ADDENDUM NO. 3

DATE: July 14, 2016
FROM: City of Grand Junction Purchasing Division
TO: All Offerors
RE: RFP-4267-16-DH New Data Center Server Cabinets and Cold Aisle Containment for New City Hall I.T. Server Room Project

**GRAND JUNCTION, CITY HALL
 SERVER ROOM**
 250 N. 5TH STREET
 GRAND JUNCTION, COLORADO

ORTHOGRAPHIC VIEW'S OF SERVER RACK

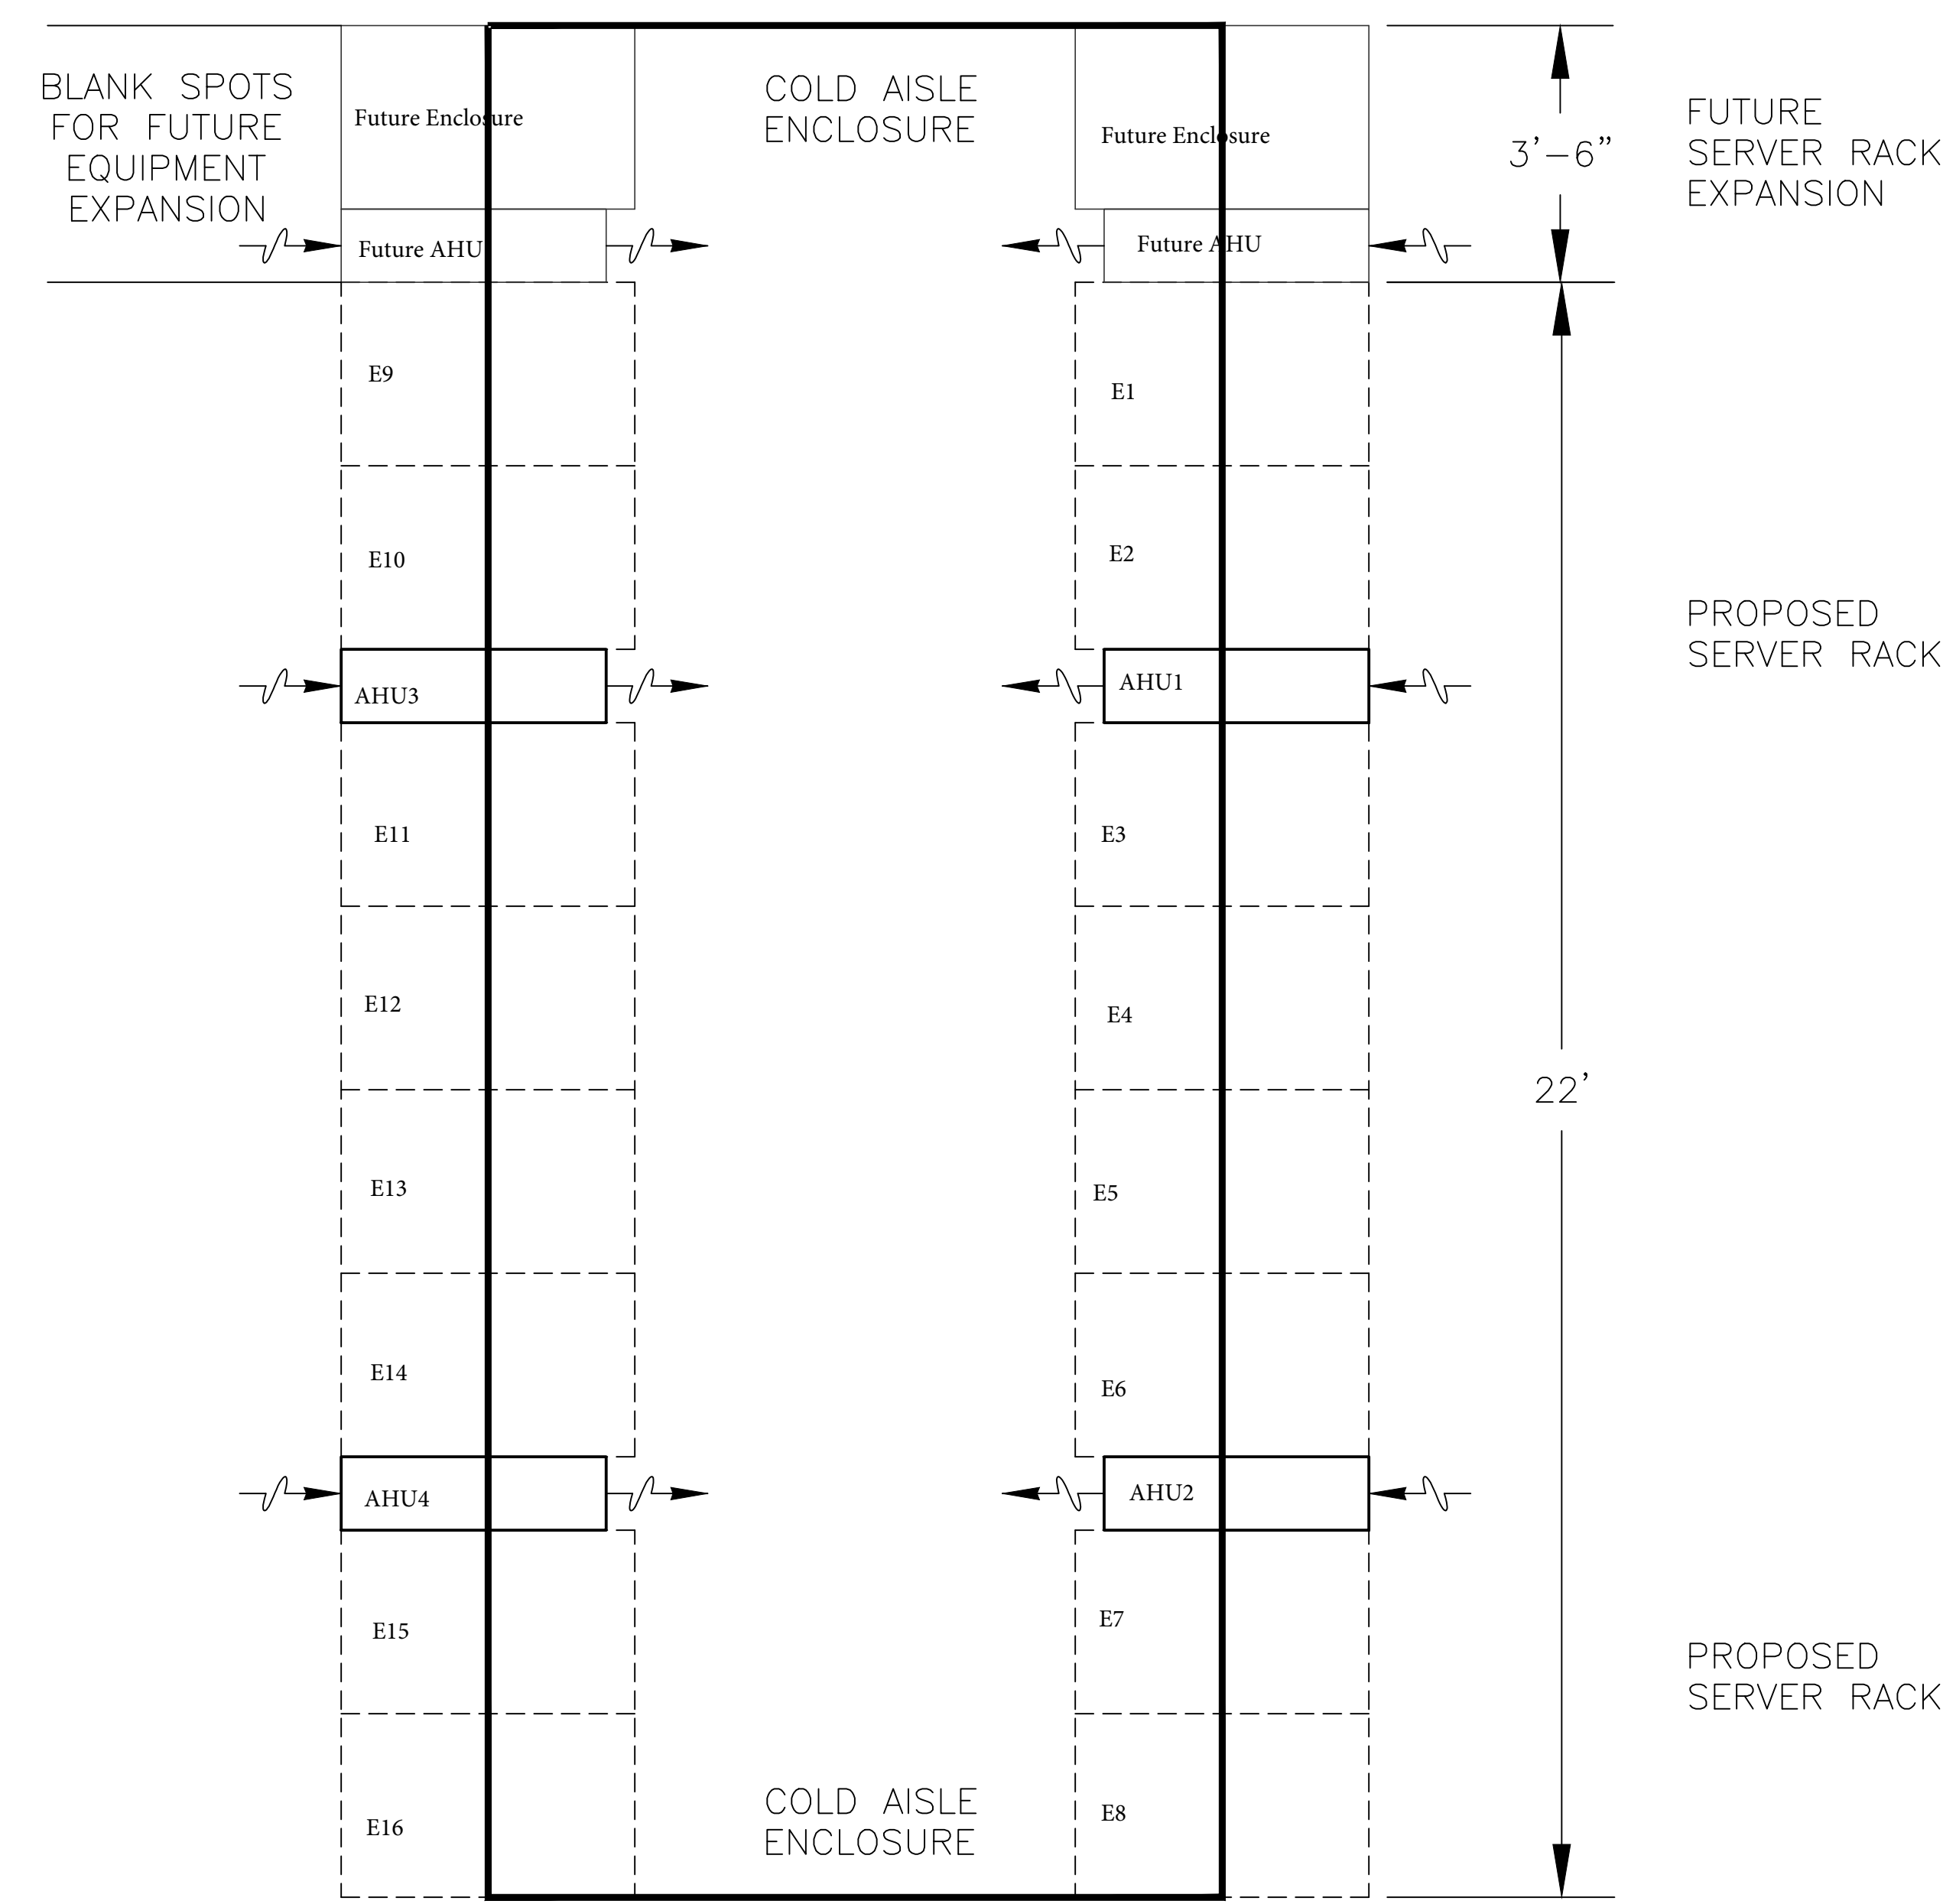
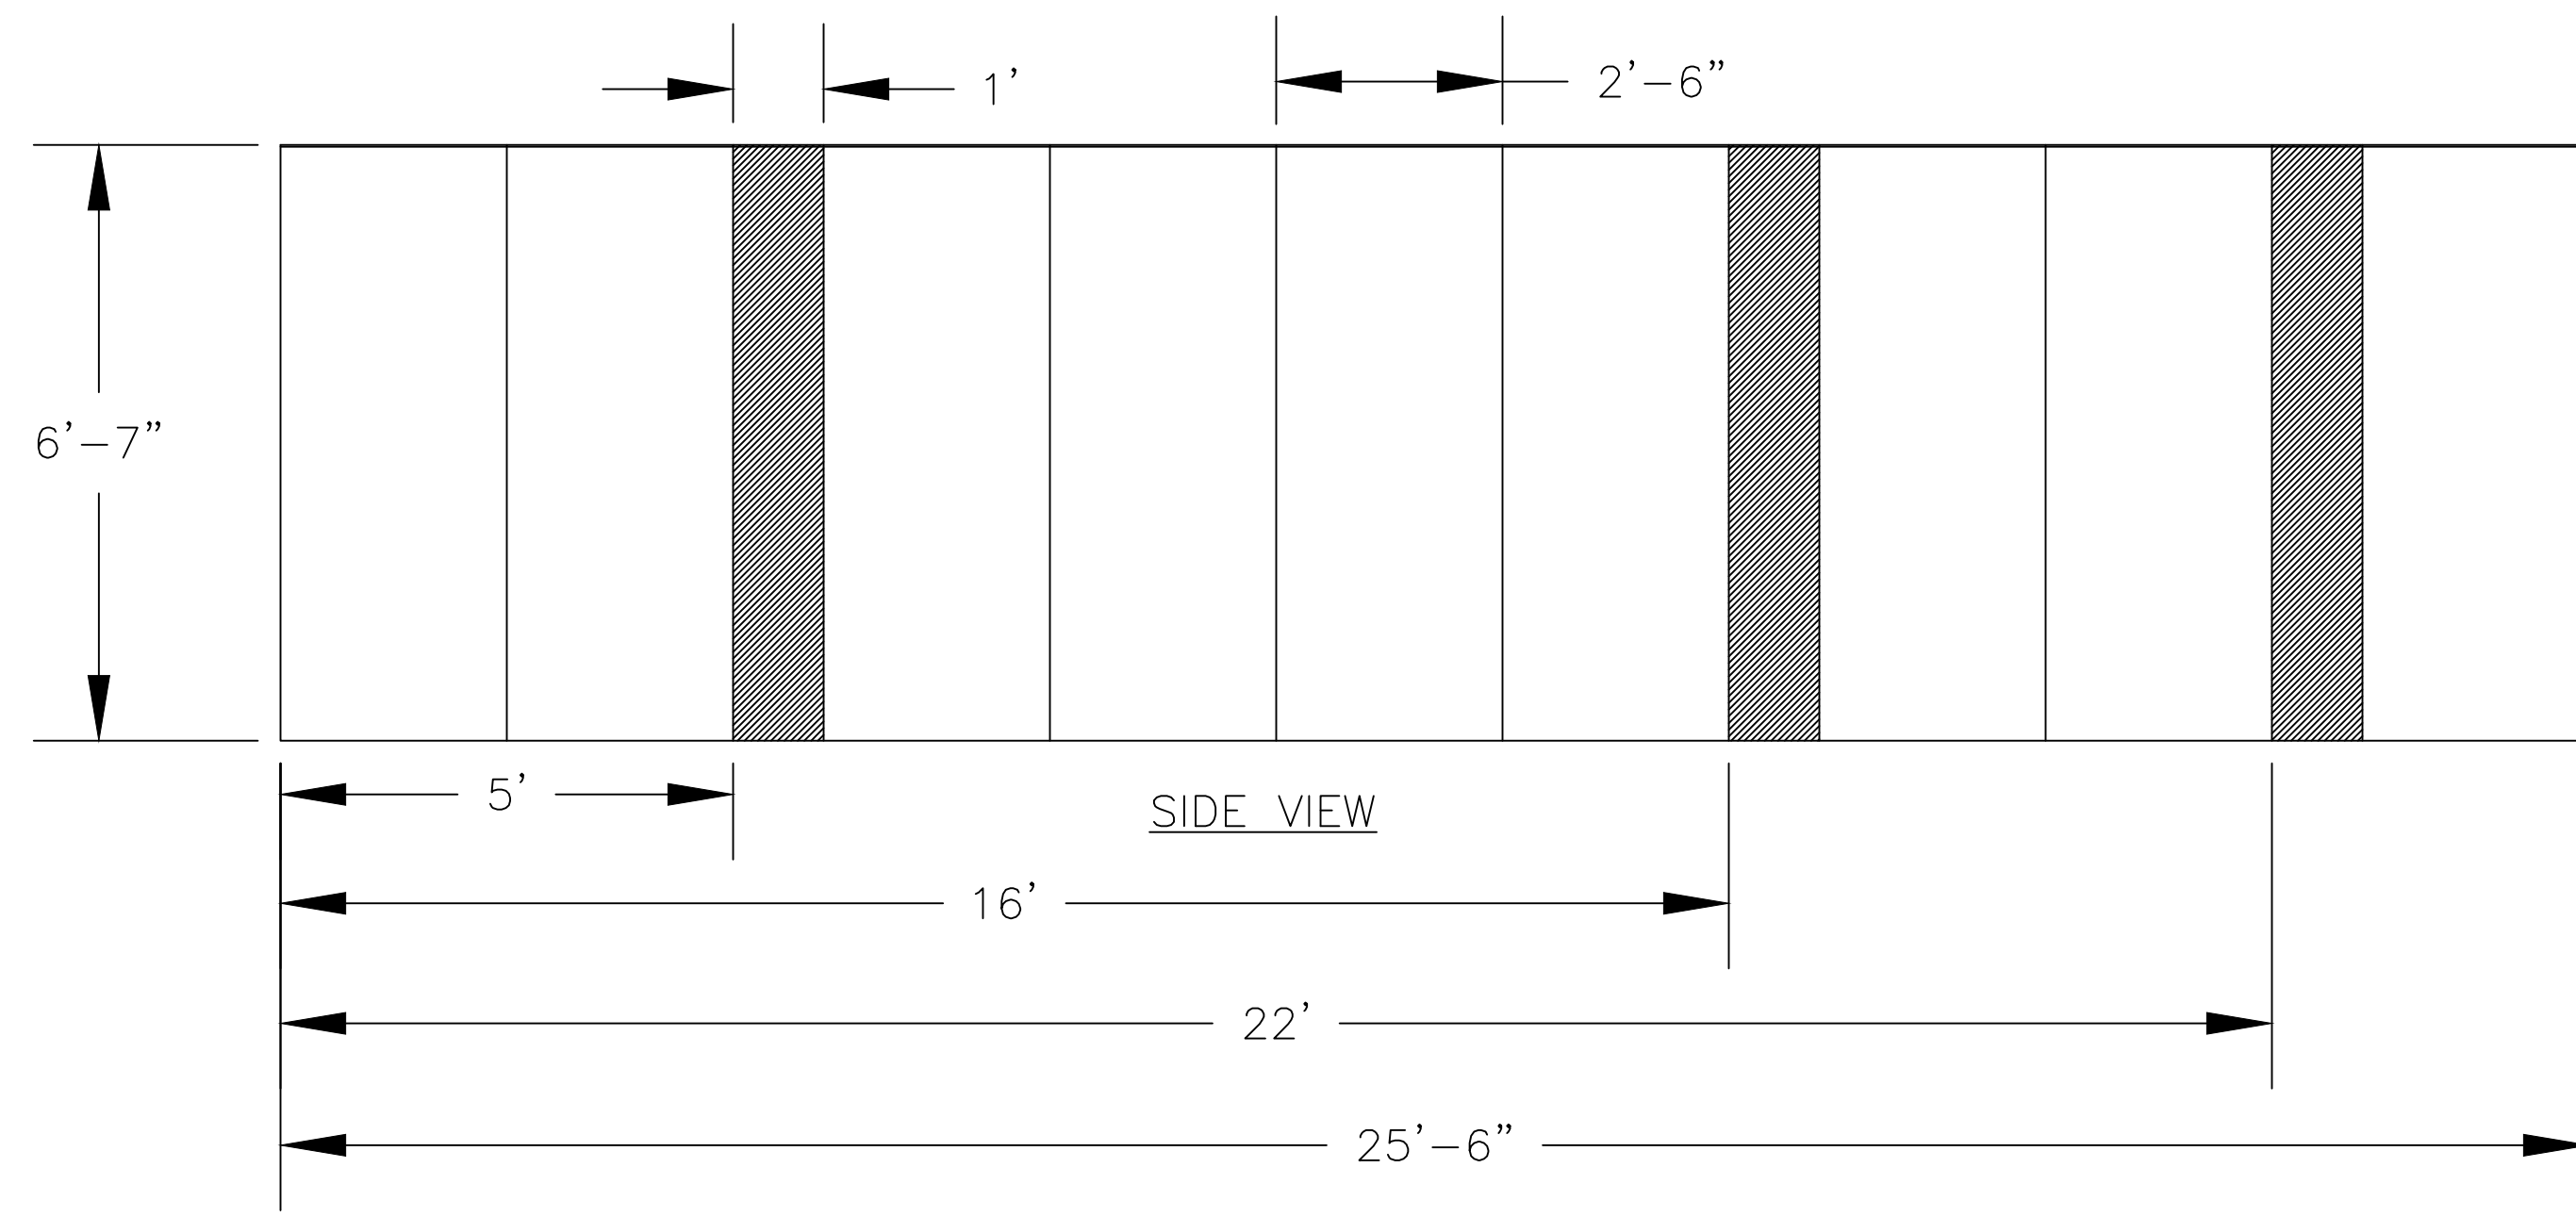
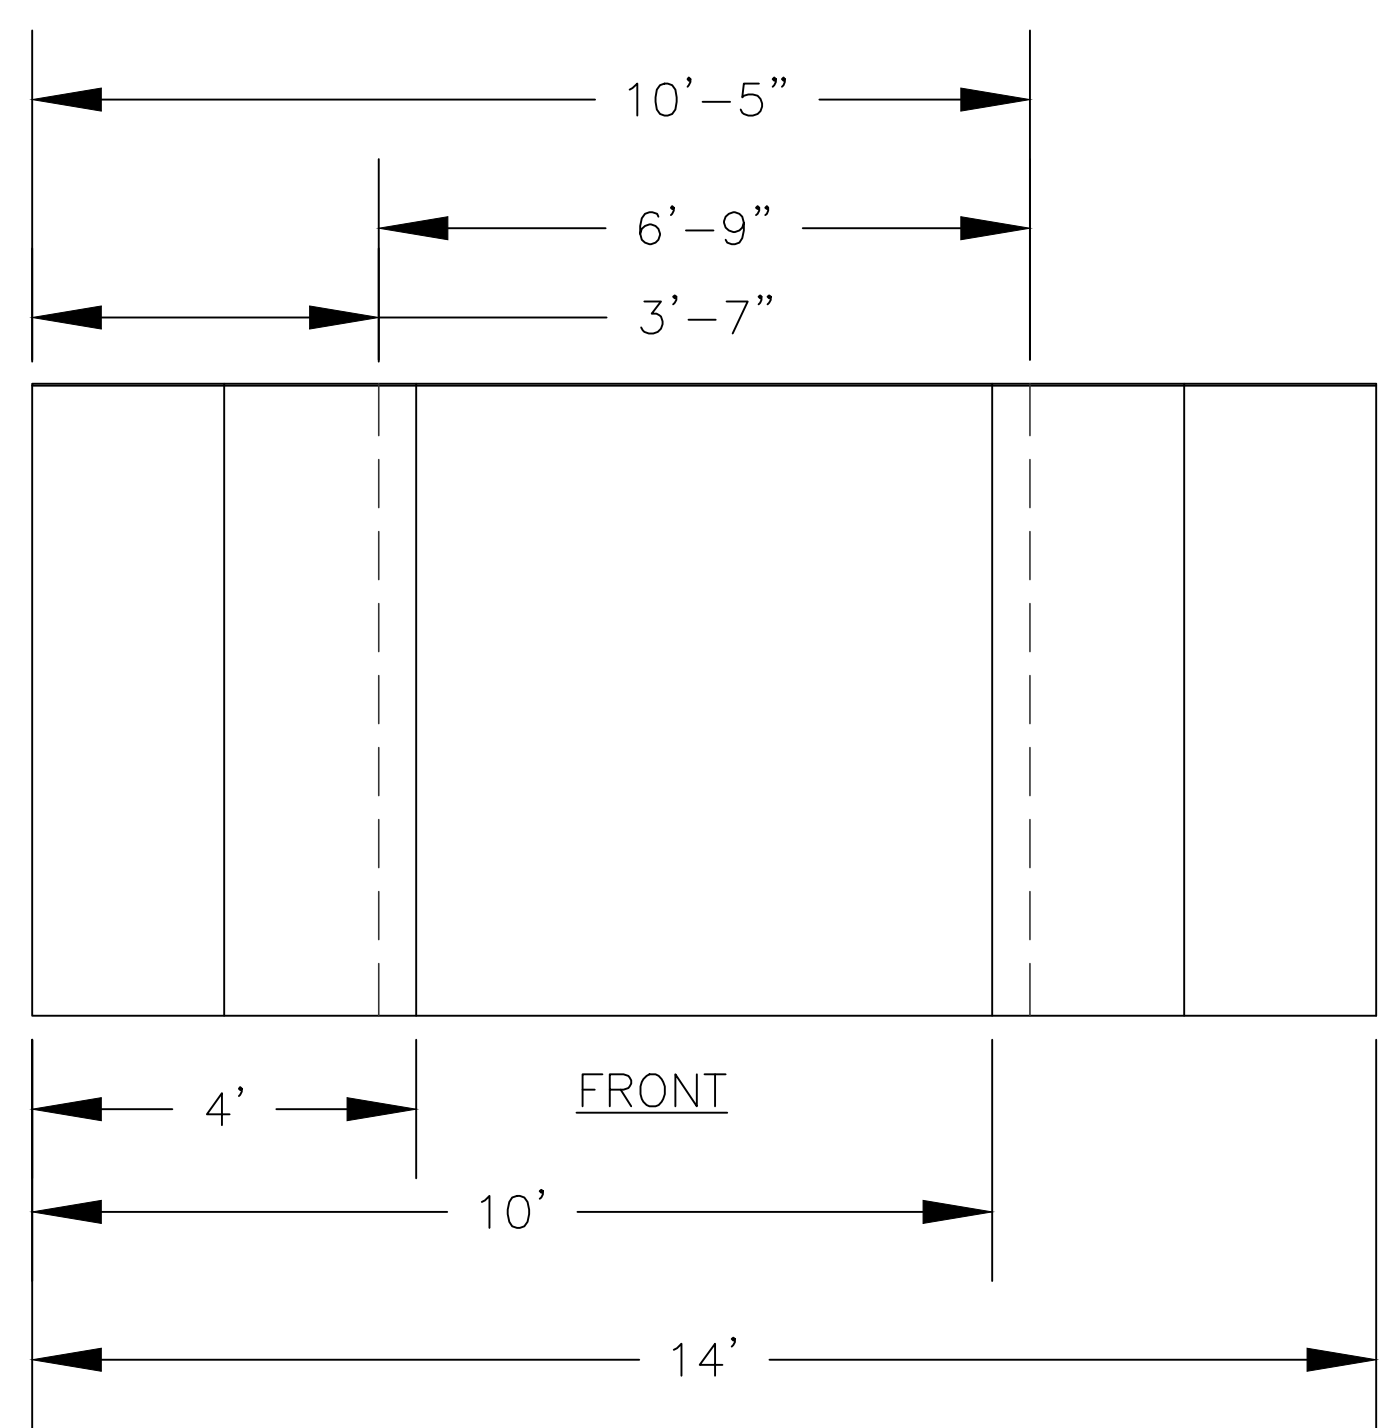
1. Q. Is 12" distance required from roof?
A. This can be deviated.
2. Q. For the crack units, is height adjustment available?
A. No, not adjustable. Contractor shall need to fill the gap.
3. Q. What is the cold aisle width?
A. See attached drawing.
4. Q. Can cabinets be used to support structure?
A. Yes.
5. Q. Can swing doors be used instead of slider doors?
A. Contractor shall submit pricing and proposal as per the solicitation documents, which currently state slider doors. However, if the Contractor has alternate concepts for the cabinets (such as a swinging door vs. a sliding door), they may submit an "Alternate" proposal in addition to their primary proposal.
6. Q. Can the doors be transparent or do they need to be solid with windows?
A. As long as you can see through them and allows light through.
7. Q. Do roof panels in the cold aisle need to be transparent?
